CITY OF SAN BRUNO  
CITY COUNCIL

Re: California Coastal Analyses and Mapping Project / Bay Area Coastal Study

## TECHNICAL RESPONSE TO FEMA COMMENTS

Figure 1: Exhibit of DHI Bay Model Output Locations

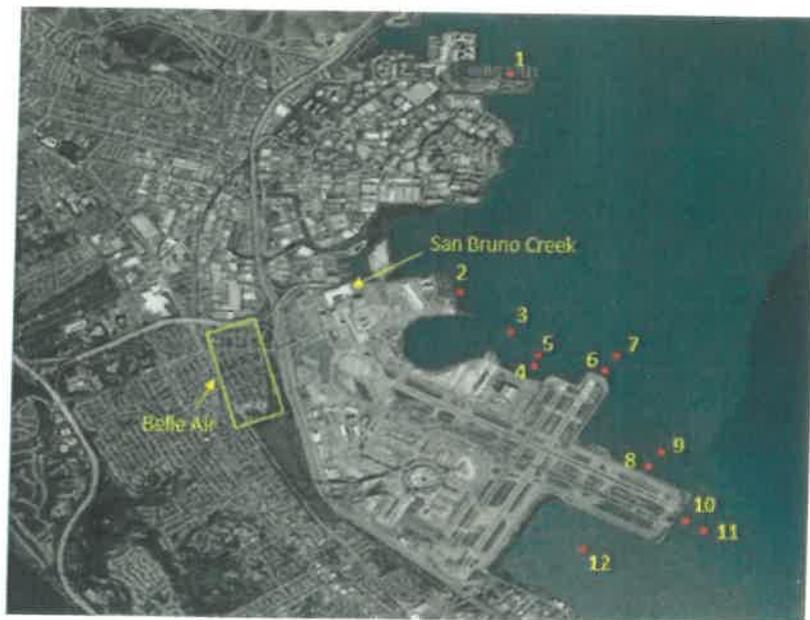
*The "design storm" hydrograph used in this submittal is event-based and developed to represent a single event consistent with a 1-percent-annual-chance flood. The M&N Report noted that the configuration of peak tides and flood duration is based on three historic coastal flood events in January 1983, December 1983, and February 1988. The resulting combination is scaled to a peak storm tide of 10.4 feet NAVD88 equal to a 1-percent-annual-chance flood level used in the Preliminary FIS and FIRM at the boundary with San Francisco Bay. The hydrograph used in this submittal was based on measured event data for the January 1983 storm, December 1983 event, and February 1988 event as recorded at the NOAA Alameda gage. It was not clear why more representative local gage measurements for the three events along the western bay shoreline were not used, such as those measurements at NOAA tide gages at Oyster Point Marina (NOAA #4392) and San Mateo Bridge (NOAA #4458), located north and south of the appeal area.*

1. No recorded data or shape from NOAA tide gages were used in the modeling conducted for the appeal. The shape of tide series was from the FEMA's Bay model and the peak elevation was based on FEMA's BFE in the Bay.
2. The base storm event used to develop the shape was the February 1998 event (not February 1988 as listed in the comment).

As stated in Section 3.2.1 of M&N Report, the 54-year water level time series developed for FEMA's "Regional Coastal Hazard Modeling Study for North and Central San Francisco Bay" (DHI, 2011) were utilized. The DHI study developed hourly water levels between 1956 and 2009 along the entire San Francisco Bay coast. Figure 1 below (Figure 7 in M&N Report) shows twelve DHI model output locations where time series of hourly water surface elevations were available (DHI, 2011). Comparison of water level time series at the 12 locations indicates the water levels are pretty consistent between these locations and Location 12 has slightly higher water levels than the other 11 locations. Therefore, three storm time series with the highest peak elevations at Location 12 were identified from the DHI model output and compared. The hydrograph pattern of the February 1998 time series ("shape" of the hydrograph to develop tidal duration) was selected as it has the longest duration of elevated water levels; hence, it is a relatively more conservative event. The February 1998 time series were then scaled to match a peak storm tide of 10.4 feet NAVD88, which is the 1%-annual-channel flood level used in Preliminary FIS and FIRM at the boundary of San Francisco Bay.

**Table 1: Storm Events with Elevation above 9.0 ft NAVD88 (Extracted from 54-yr time series, DHI 2011)**

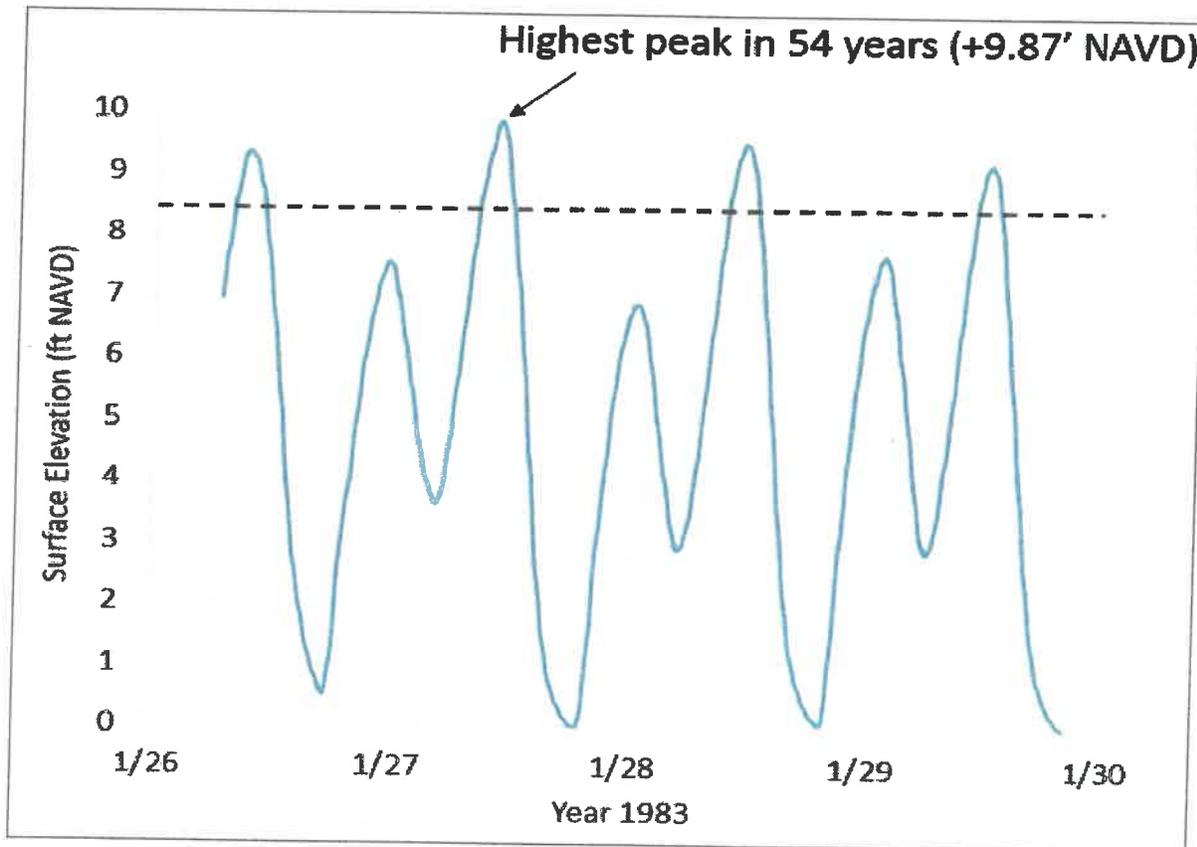
*The most notable deficiency found in the M&N Report and technical approach is the use of the event-based approach, which conflicts with the latest recommendations developed by FEMA for the Pacific Coast region in 2005 for use in San Francisco Bay and open Pacific coast. In this FEMA Pacific coast guidance, an approach was presented for evaluating the 1 -percent-annual chance flood, based on the concept of "system response analyses" rather than traditional "event analyses." This means that the open waters of inland bays and oceans should follow the response approach, which uses a historic record of measured or predicted wave conditions along with simultaneously measured or predicted water-levels to determine site-specific storm response parameters, such as maximum water levels at points of interest. This approach is more robust than an event analysis that relies on a set time-dependent wave level condition with a specific duration. To be consistent with a "system response analysis," the appeal should have utilized water levels driven by the FEMA 54-year hindcast study as boundary condition forcing to the XP-SWMM modeling. This would allow for the largest response from each of the 54 years to be used as annual maxima for the entire period of record and analyzed (by statistical analysis) to determine the 1-percent-annual-chance flood response for overland flow conditions. Any new modeling should follow the FEMA Pacific region guidance and use of the existing spatially varying 54-year time series along the boundary for tidal forcing.*

The City would also like to note that the FEMA recommended response-based approach would not work for the area being appealed, which is Belle Air neighborhood south of the Pine Street. The area is potentially exposed to three flood sources as stated in Section 3.4.2 of M&N Report, but it would not be flooded even under the largest storm events. The three potential flood sources and flood risks are:

- 1) San Francisco International Airport (SFIA). The flood water would overtop Hwy101 after the SFIA is flooded. The lowest elevation of that segment of Hwy 101 is +9.4 feet NAVD88. All storm events in the 54-year time series with a peak elevation above 9.0 feet NAVD88 are listed in Table 1. There is only one storm event that would have the potential to overtop the Hwy101 even assuming no flood attenuation.

- 2) Cupid Row Canal. The lowest bank elevation of the Canal is +9.2 feet NAVD88. Only four storm events would have the potential to overtop the bank of the Cupid Row Canal, again assuming no flood attenuation.

- 3) Millbrae. The low coastline of Millbrae would allow flood waters to enter and flow north along Hwy 101, and then into the Belle Air Neighborhood. The current modeling results indicate that flood waters would not reach the Belle Air Neighborhood even with a peak elevation of +10.4 feet NAVD88 due to long flood routing distance and limited flood duration and flood volume.

In summary, if the suggested response-based approach is used by applying the 54-year time series at the model boundary, there would only be four potential storm events in the Bay as shown in Table 1 that would have the potential to flood the northern part of the Belle Air Neighborhood and none that would reach south of Pine Street. Four storm events are statistically insufficient in terms of sample space to perform extremal analysis to result in the 1%-annual-chance of flood. A more detailed discussion about why a response-based approach would not work is detailed below.
